INDIANA DEPARTMENT OF TRANSPORTATION

STANDARDS COMMITTEE MEETING

FINAL AGENDA

November 20, 2008 Standards Committee Meeting

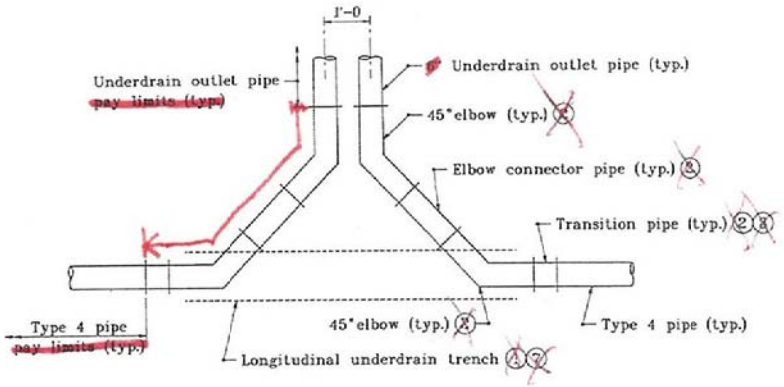
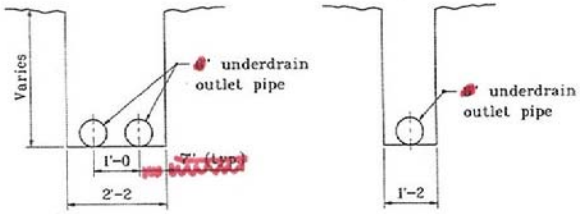
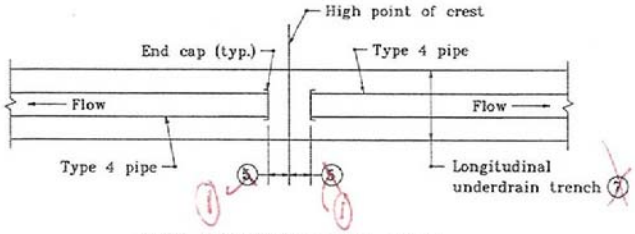
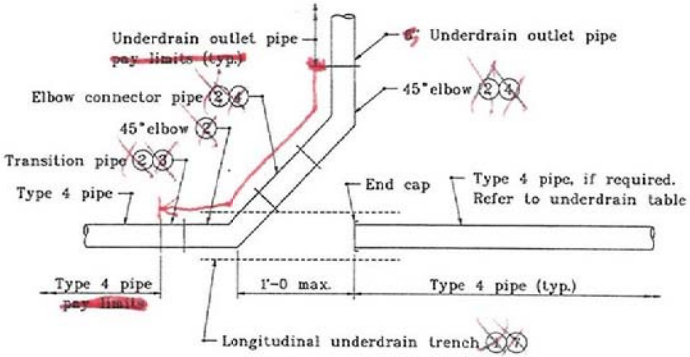
PROBLEM(S) ENCOUNTERED: In February 2008, Pay Limit information was removed from Standard Drawing E 718-UNDR-01 and placed in the Standard Specifications. For consistency, General Notes on E 718-UNDR-07 should be revised to place appropriate information in the Standard Specifications.

PROPOSED SOLUTION: Remove specification related information from General Notes on Standard Drawing E 718-UNDR-07 and place in appropriate part of 718. Revise Standard Drawings E 718-UNDR-01, E 718-UNDR-02, E 718-UNDR-03, E 718-UNDR-04, E 718-UNDR-05 and E 718-UNDR-07 to reflect changes.

1. Standard Drawing E 718-UNDR-07 for General Notes pertaining to this sheet.

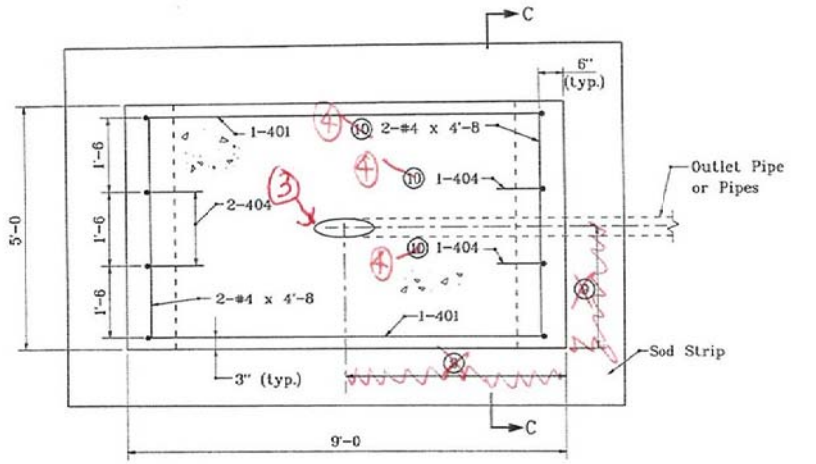
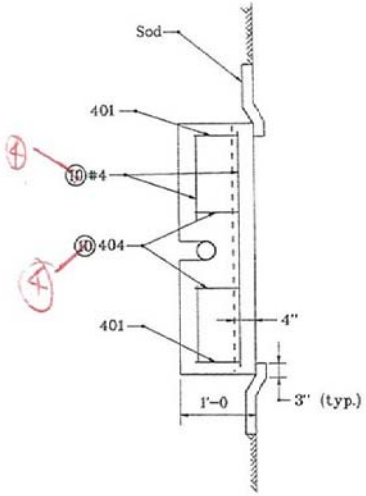
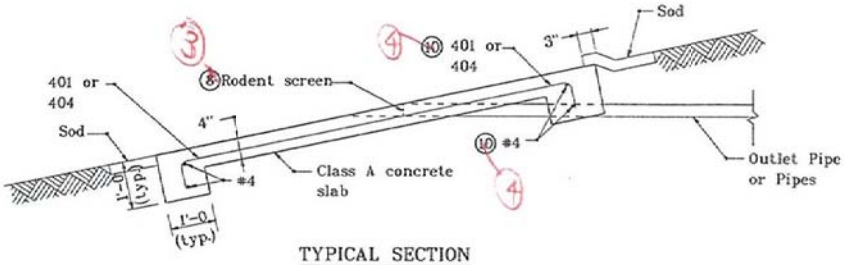
1. See Standard Drawing E 718-UNDR-07 for General Notes ~~pertaining to this sheet.~~

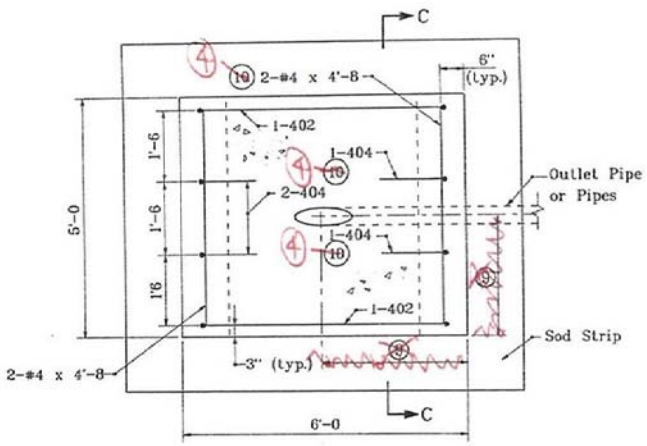
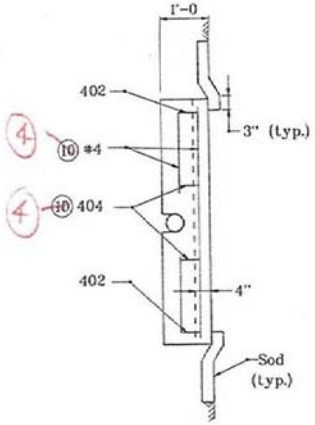
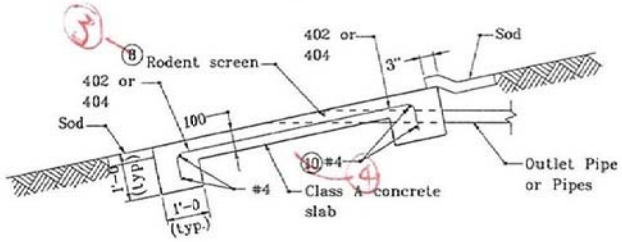
1. See Standard Drawing E 718-UNDR-07 for General Notes ~~pertaining to this sheet~~.

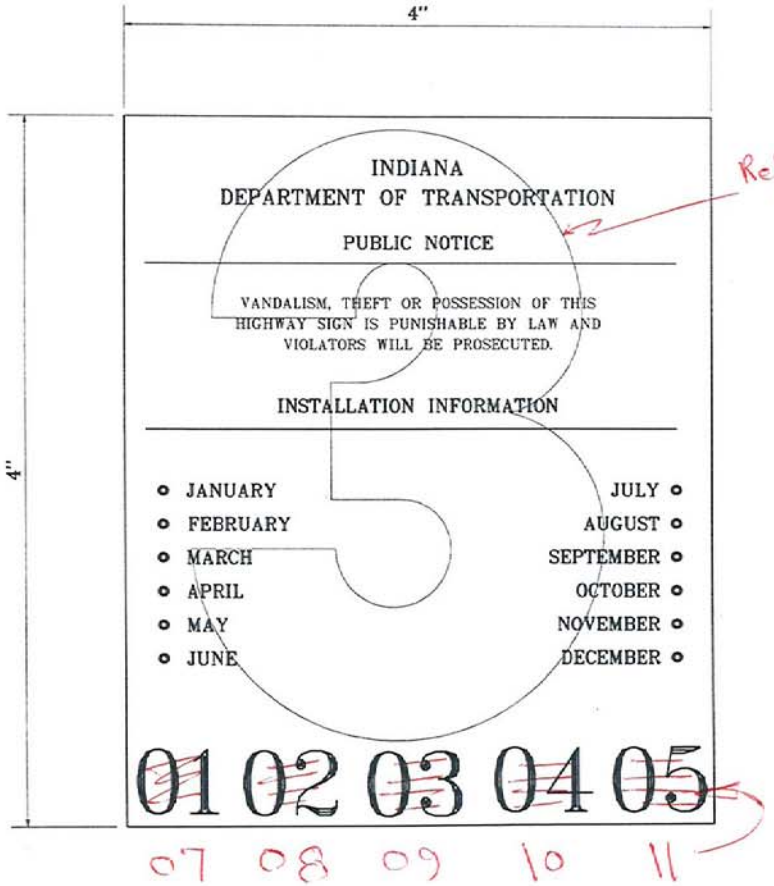
PROPOSED SOLUTION: To keep the life of the Identification marking reflective sheet the same as of Sign face, revise 802.01 to use reflective sheet type III or higher in place of type II. Revise Standard Drawing E 802-SNGS-11 to reflect changes to specification.

1. Height of lettering shall be $\frac{1}{8}$ in. to $\frac{1}{4}$ in. The height of the dates along the bottom shall be $\frac{1}{2}$ in.
2. Copy shall be black on ~~reflectorized~~ white ~~background~~. Reflective sheet Type III or higher
3. The number of dates along the bottom need not be five, and the first date need not be ~~01~~ 07 However, the installation date shall be shown.
4. The month and year of installation shall be punched by a $\frac{1}{4}$" minimum diameter hole.
5. The overlay number to be of colored transparent sheeting to indicate the last digit of the year of installation.
